## **REVIEW COMMENTS**

**FILE #SPR-96-34**

**TITLE HEADING:** Schroeder Building - 4 Apartments on

the 2nd Floor and Carports

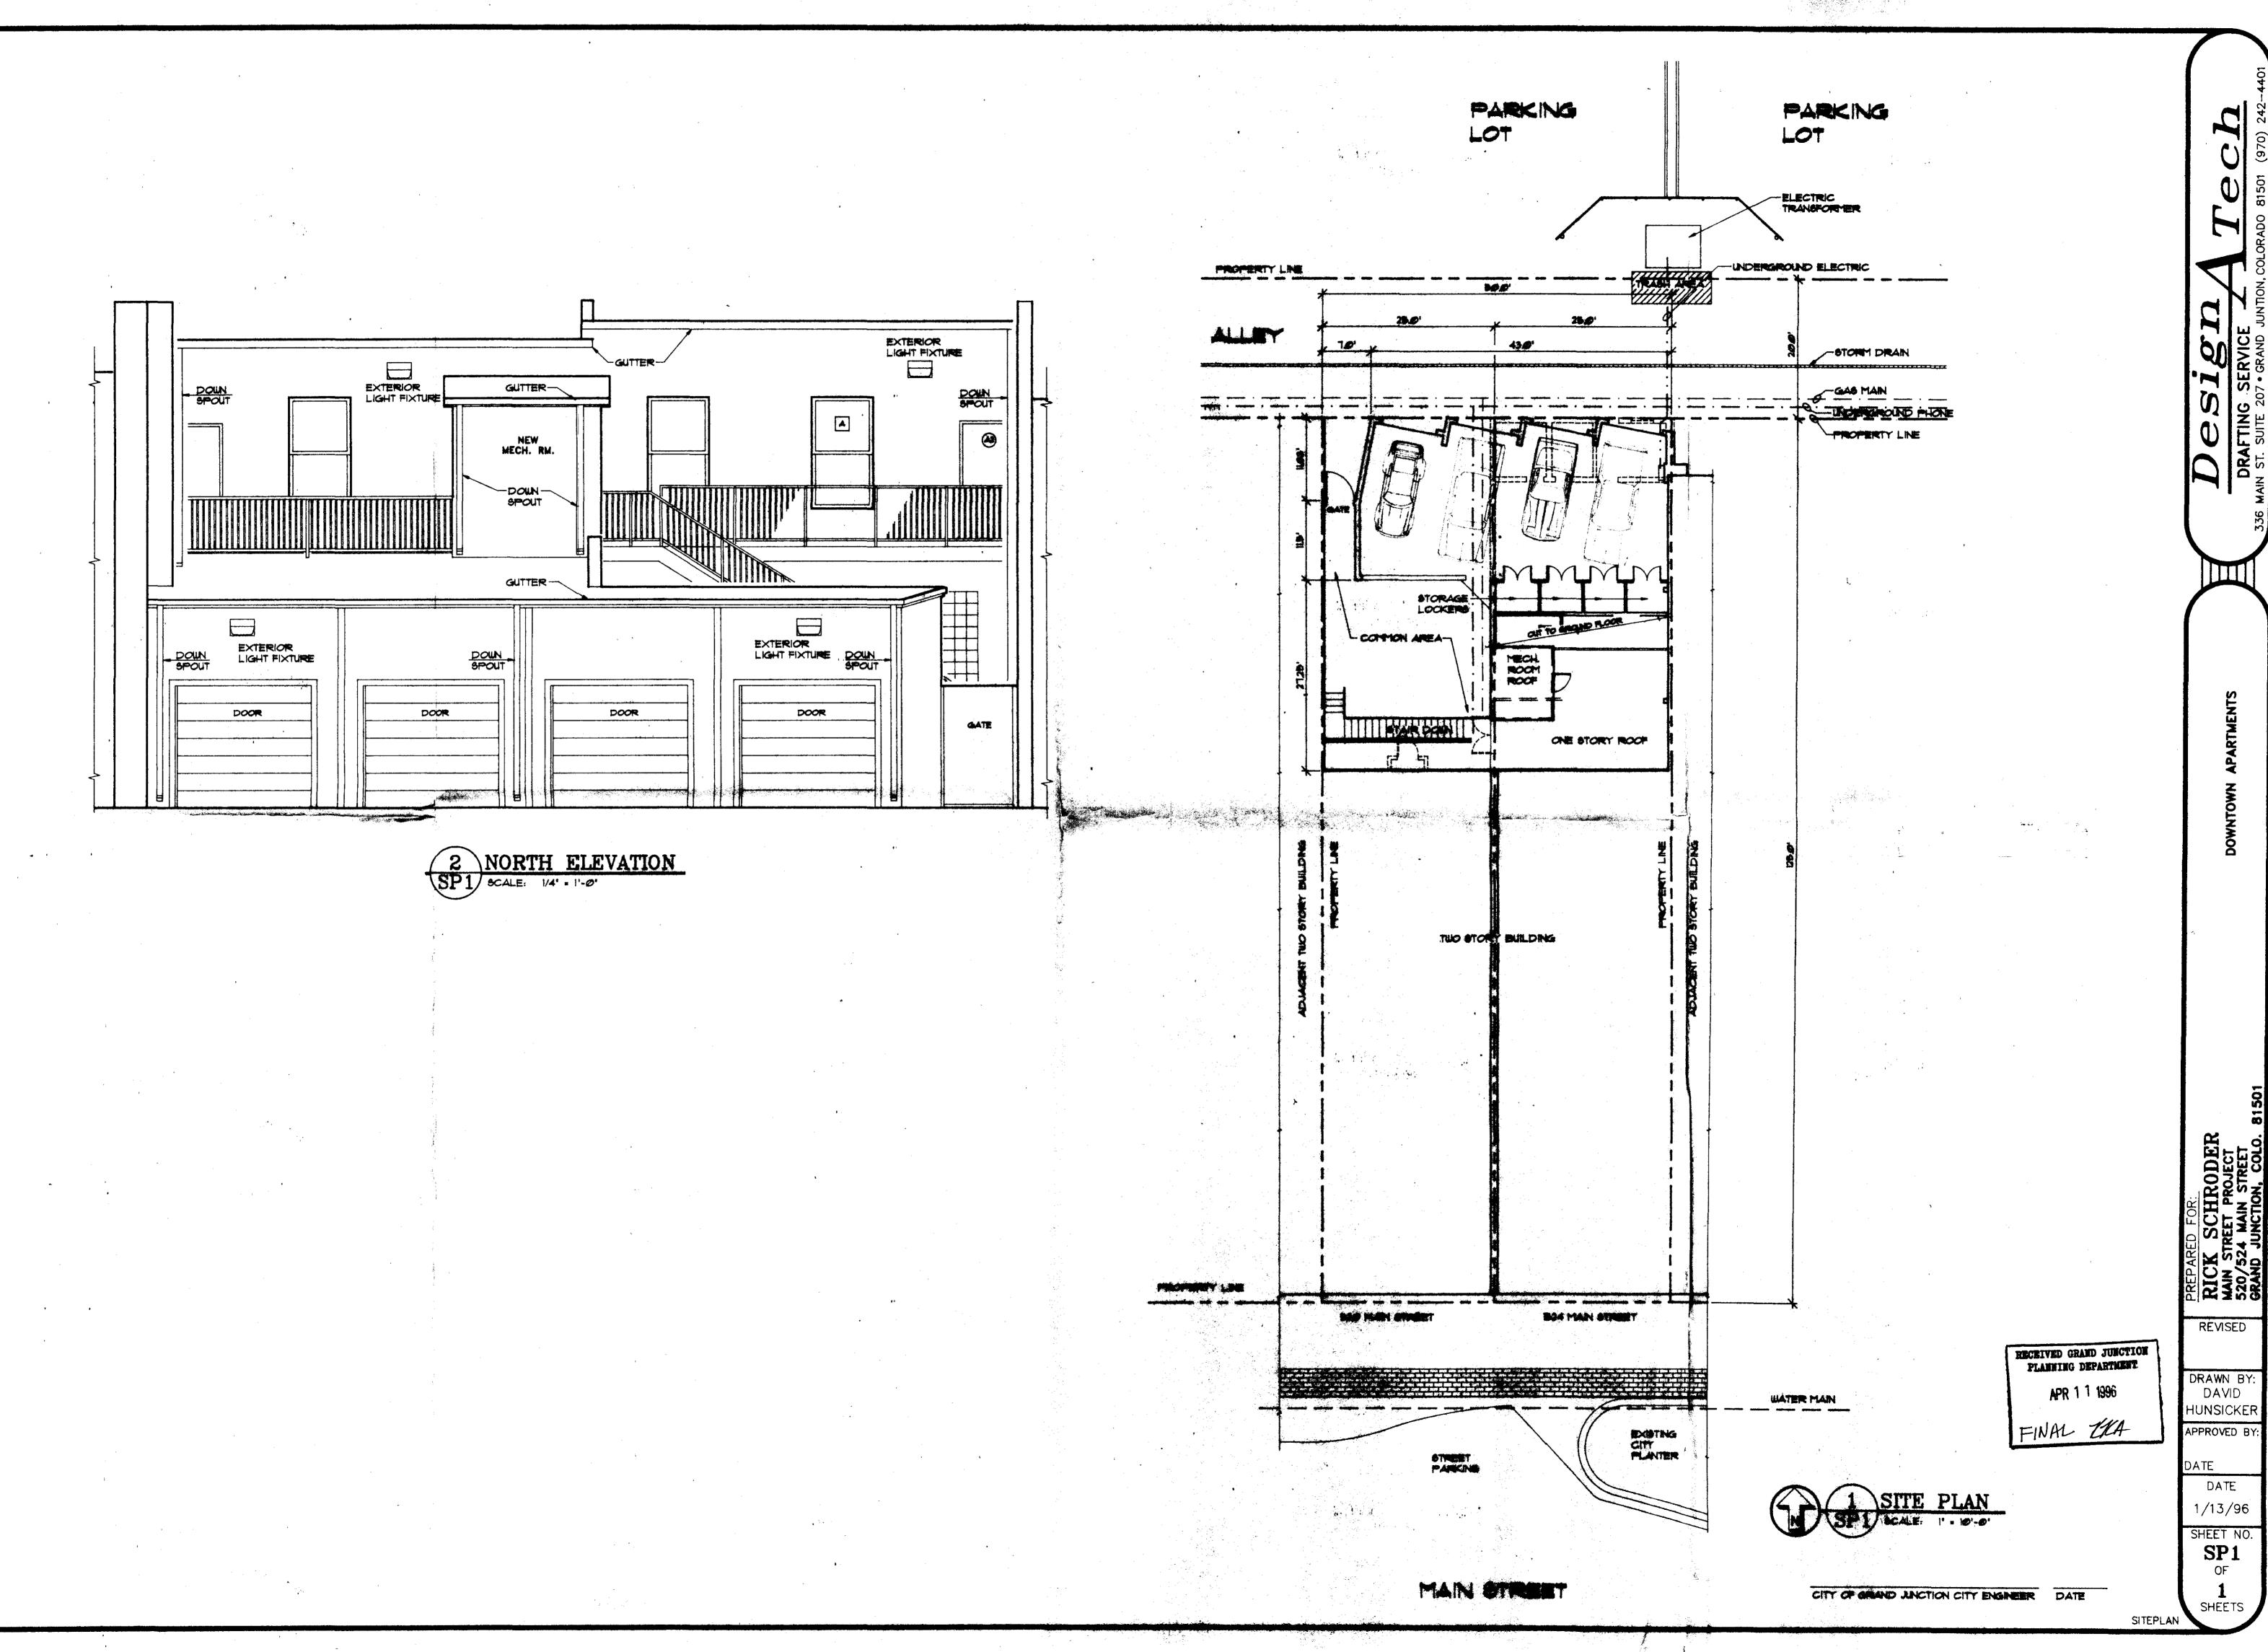
- 1. Are these garages or just covered carports? If they are mere carports, I don't encourage any type of covering. A cover would just hide a would-be criminal from view when breaking into or stealing cars.
- 2. What type of lighting provisions are being made at ground level between the garages and the apartments (stairway area)?
- 3. Please ensure there is lighting in the covered area at the top of the stairs as well as the shown lighting on the walkway.
- 4. I would suggest that the apartment owner contact the Crime Prevention office for a security inspection prior to occupancy.

- 1. How will trash collection be handled? Is the trash area shown across the alley to be used for this building? If so, is it enclosed?
- 2. Correct spelling errors on the plan -- it is difficult to understand due to errors: "nouth"; "downshouts"; "ajasent"; "schrdor".

I have enclosed a revised drawing of the site plan with spelling correction requested in your comments.

I had the opportunity to visit with Dave Stassen and explained that the carports are covered by a roof, and that they are completely secured from the alley by garage doors. The common area and the carports are secured from the alley by a gate.

Lighting for the common area and stairs are provided by light fixtures attached to the building above the stairs. One additional light fixture will be provided under the soffit of the carport pointed toward the common area.

The site plan indicates that trash collection will be provided across the alley, and in front of the transformer and will not be enclosed.
